SITE PLAN WITH WAIVERS FOR METCO LANDSCAPE

Maintenance Facility Site Plan
Amendment

METCO LANDSCAPE INC.
Maintenance Facility Site Plan Amendment
17603 E. 23rd Avenue Aurora, Colorado

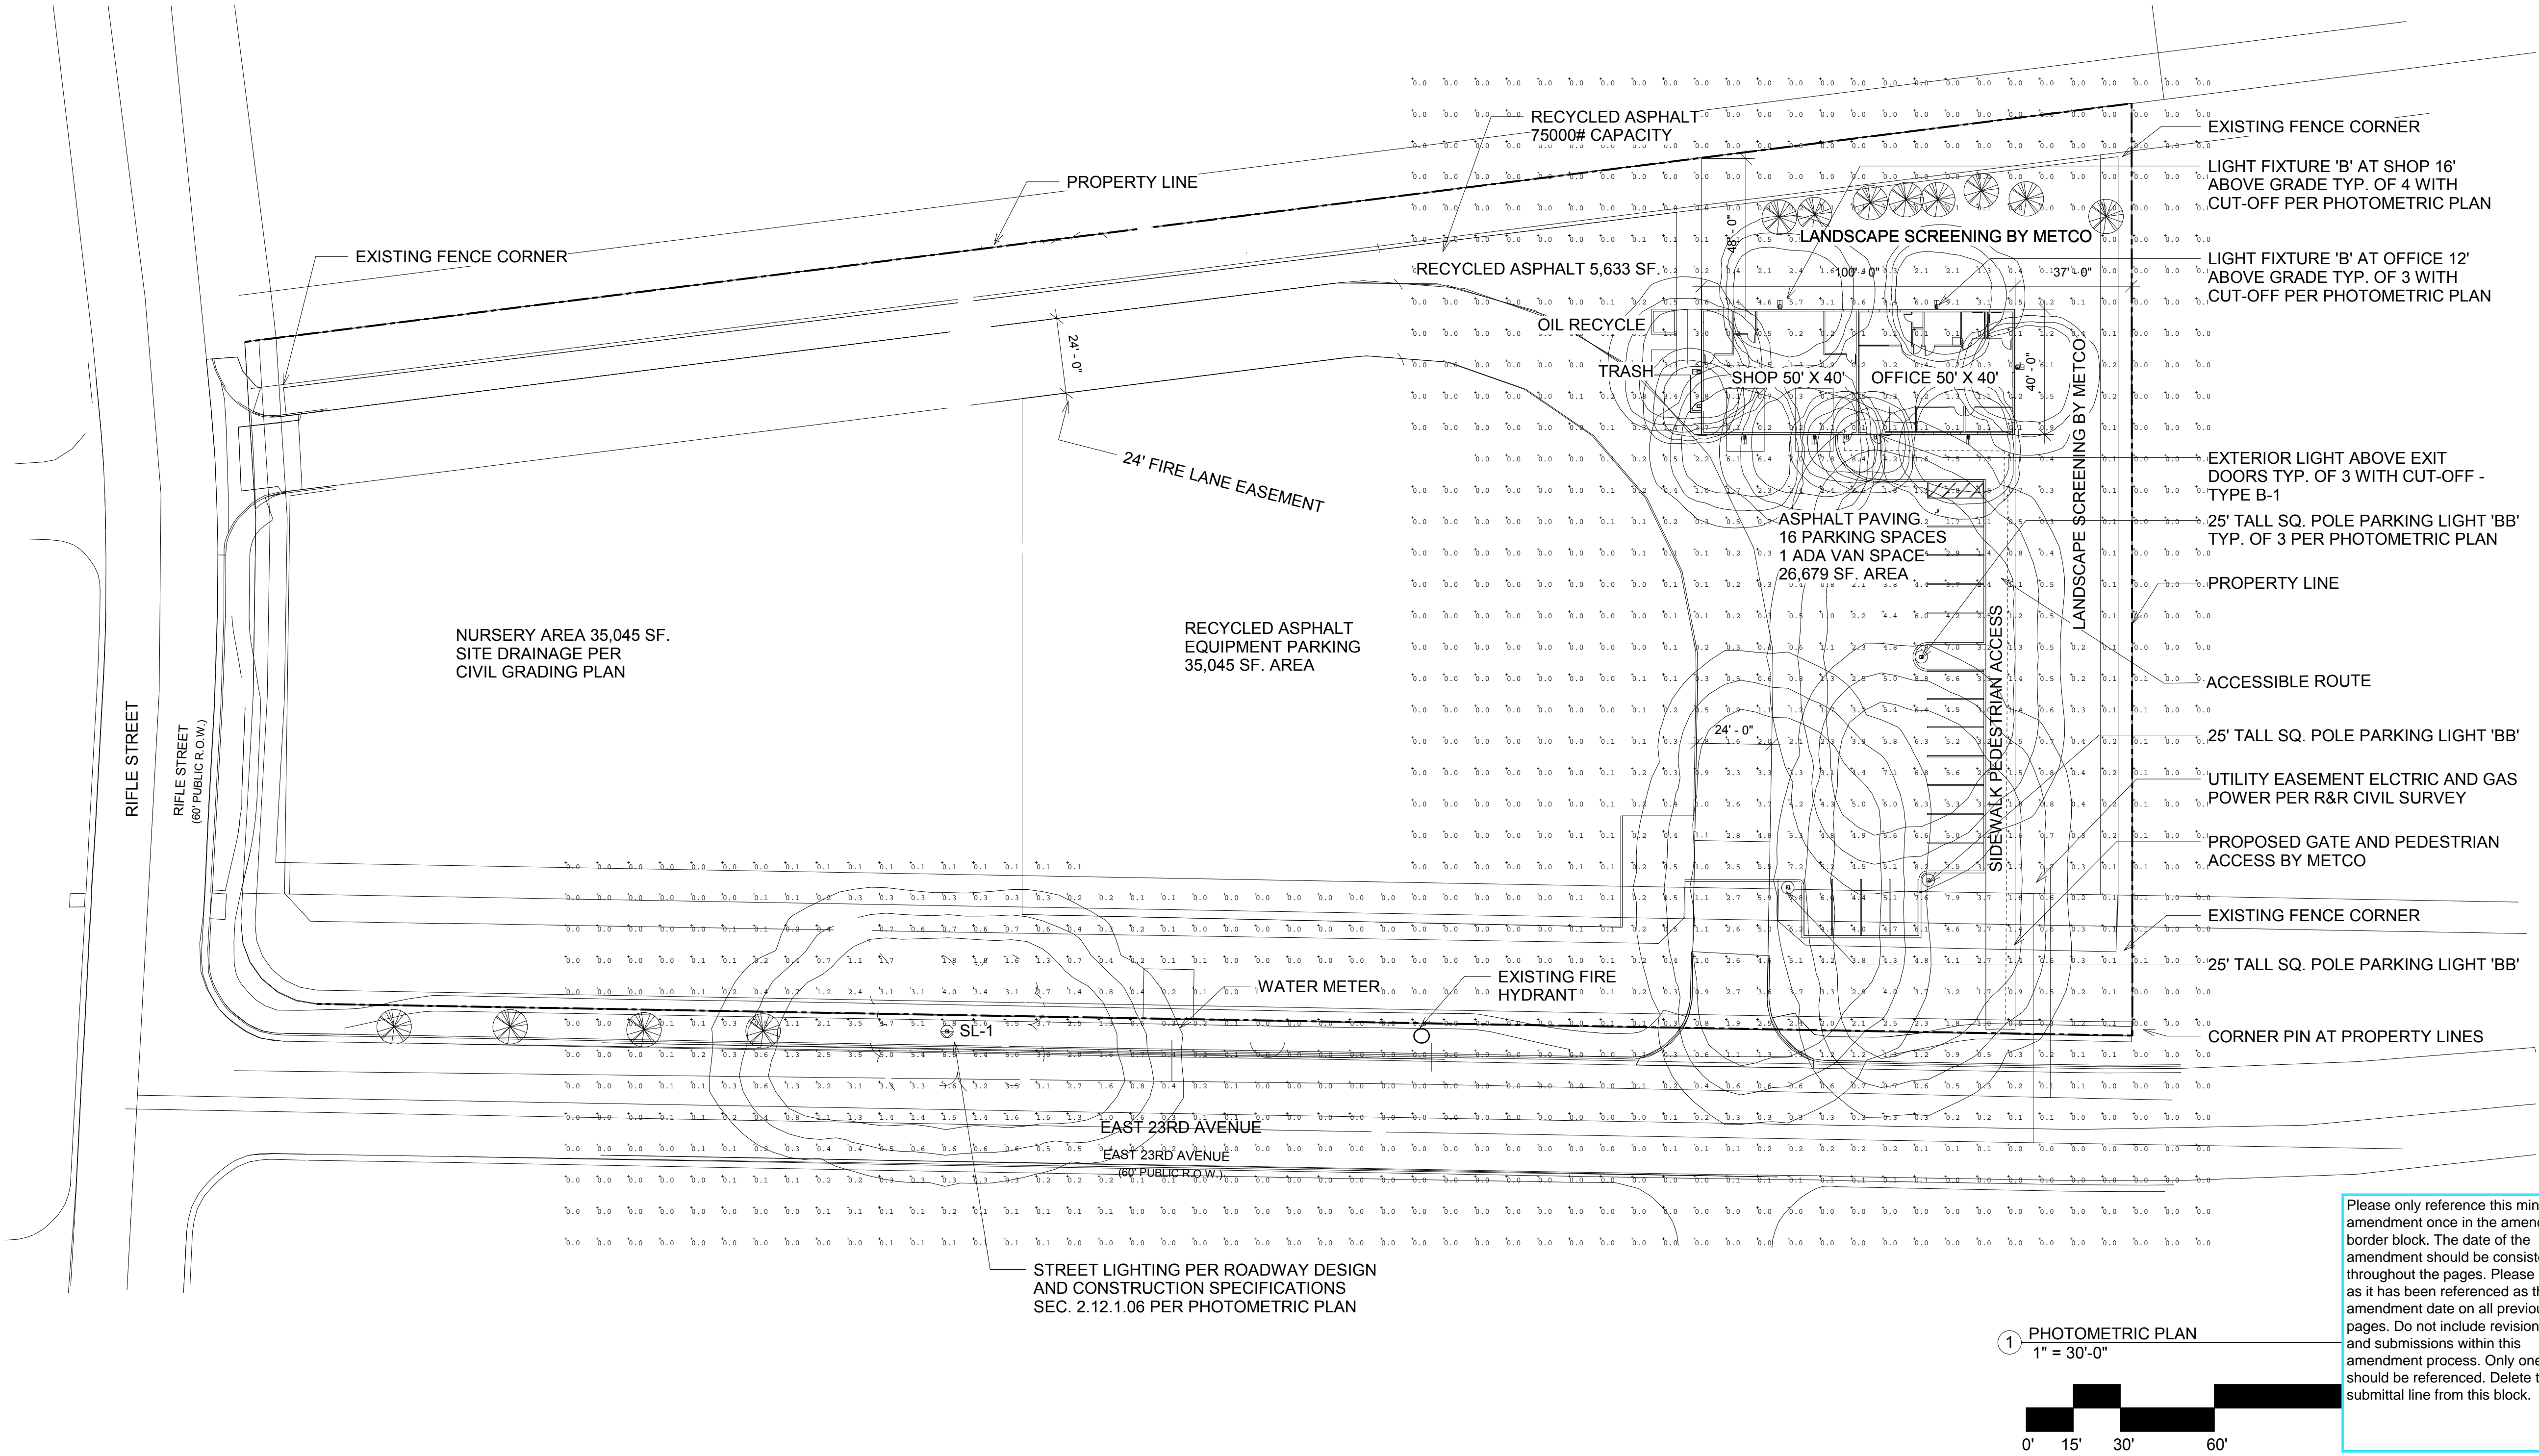
Revise this note to read "sheet 7 of 16"

Sheet Number:
Amendment
16 OF 16

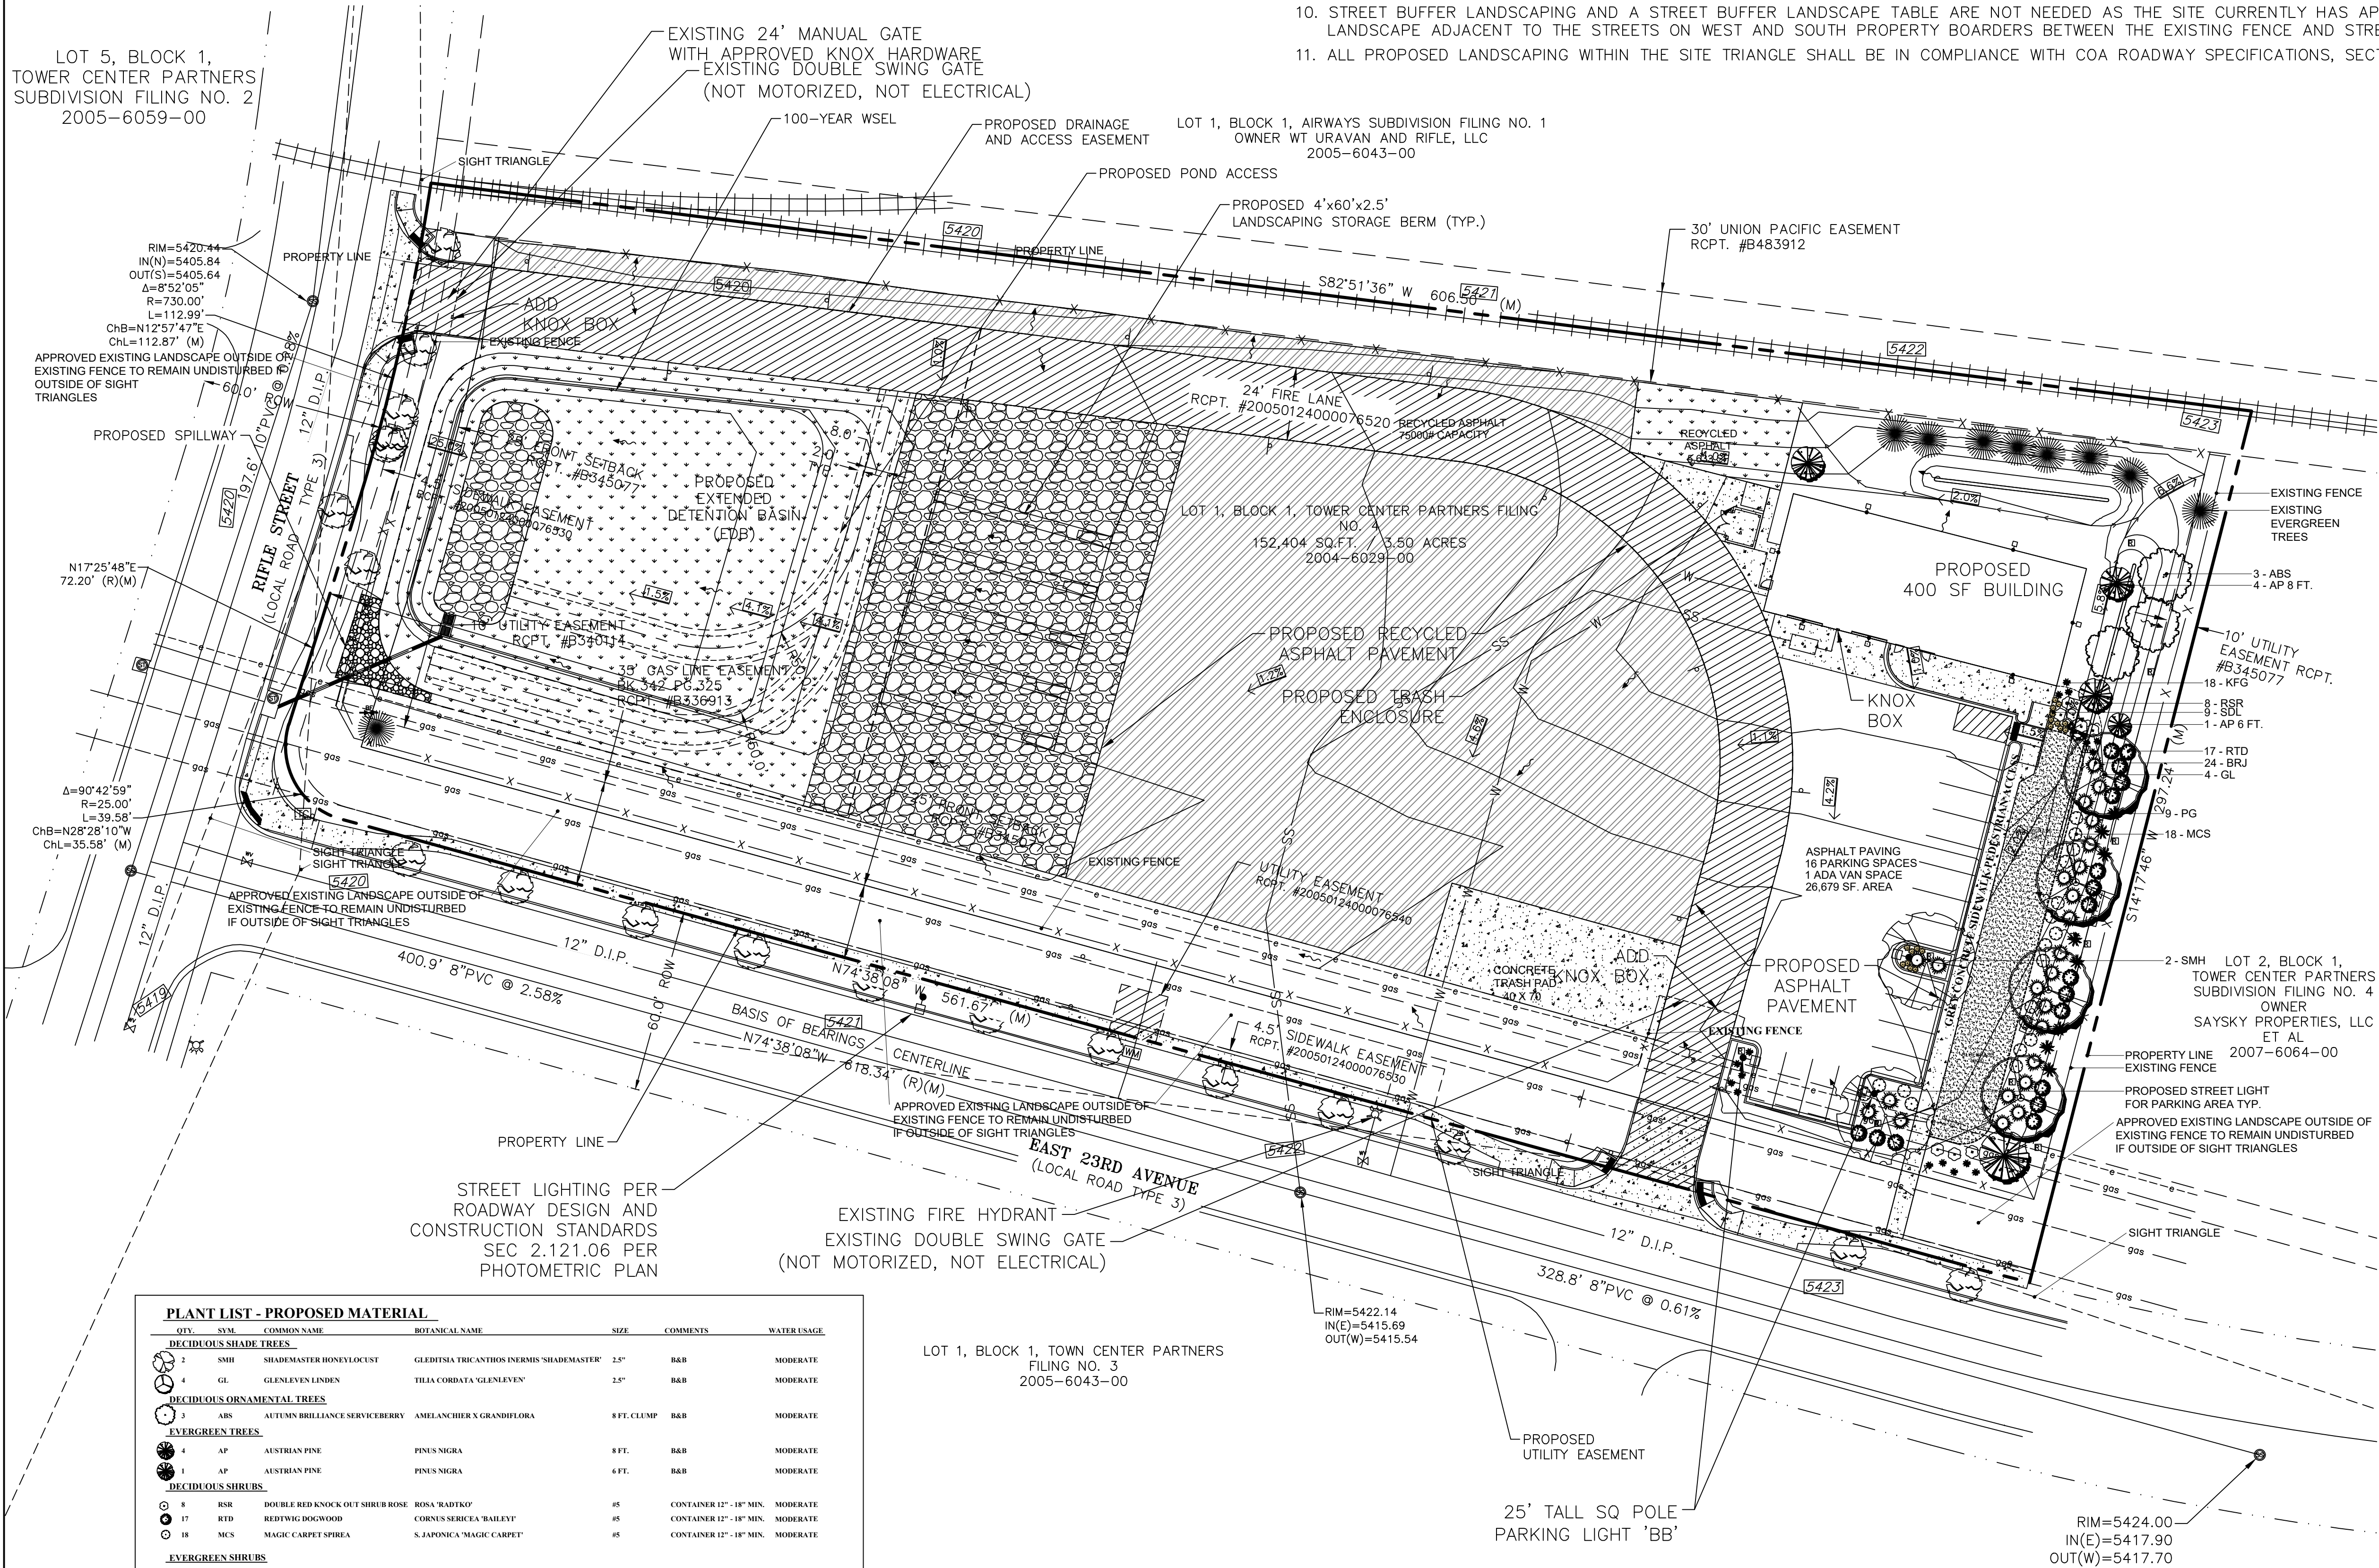
Please only reference this minor amendment once in the amendment border block. The date of the amendment should be consistent throughout the pages. Please use 7/26 as it has been referenced as the amendment date on all previous pages. Do not include revision dates and submissions within this amendment process. Only one date should be referenced. Delete the 9/20 submittal line from this block.
